| ADDENDUM 01 (REF. RFI #1) | 06/19/13 |

| SECOND FLOOR PLAN                            |

| EXPAND OIF / OEF AND BUILDING RENOVATION |              |          |        |
| VAMHCS PERRY POINT, MD 21902             |              |          |        |

1 2ND FLOOR PLAN  
SCALE: 1/8"=1'-0"

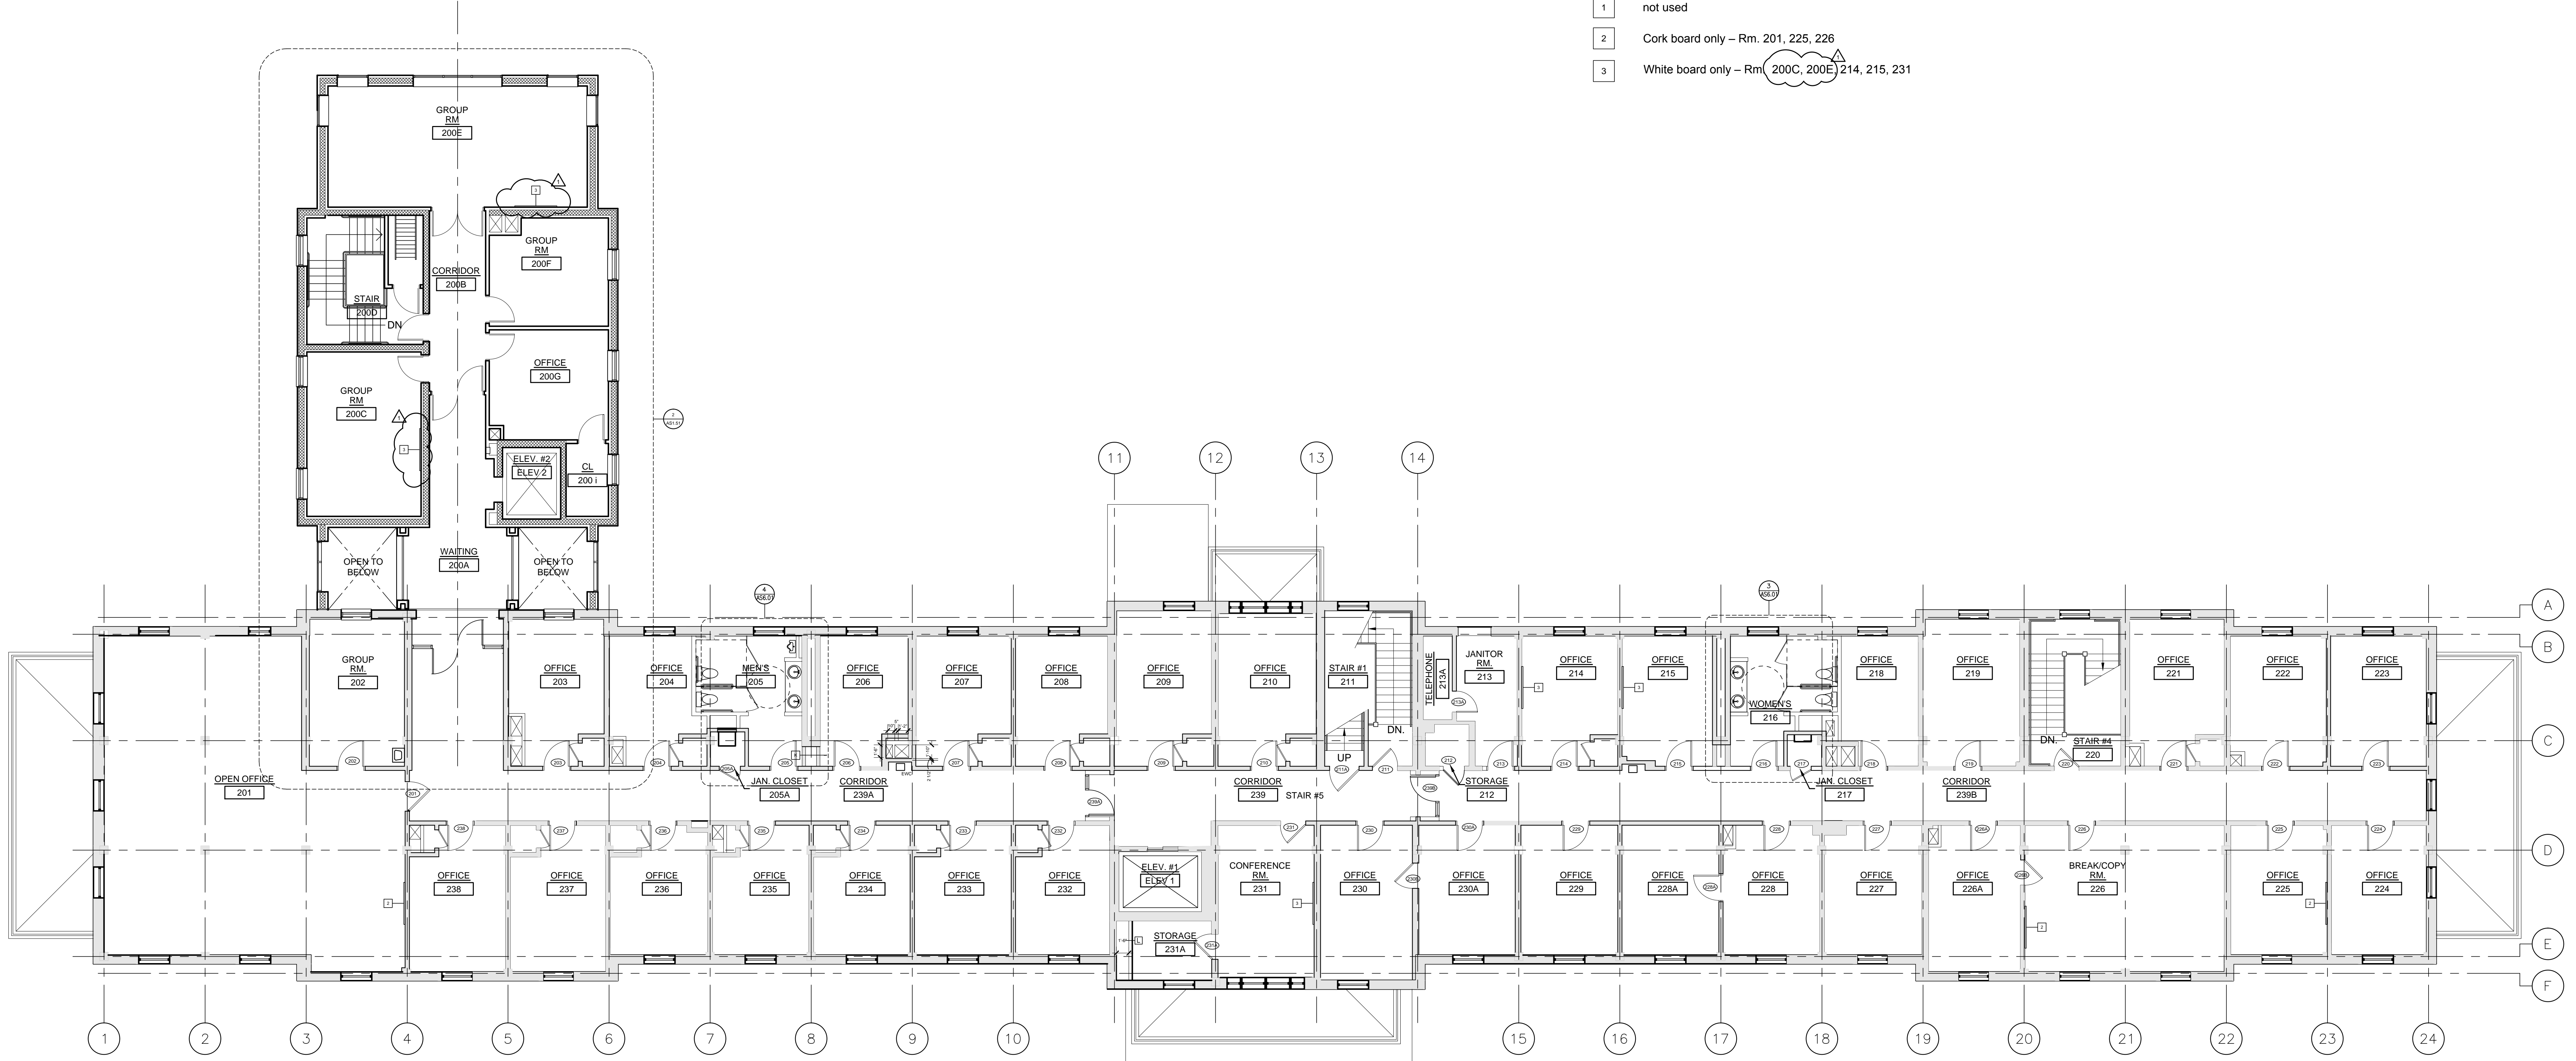
- 1 not used
- 2 Cork board only - Rm. 201, 225, 226
- 3 White board only - Rm. 200C, 200E, 214, 215, 231
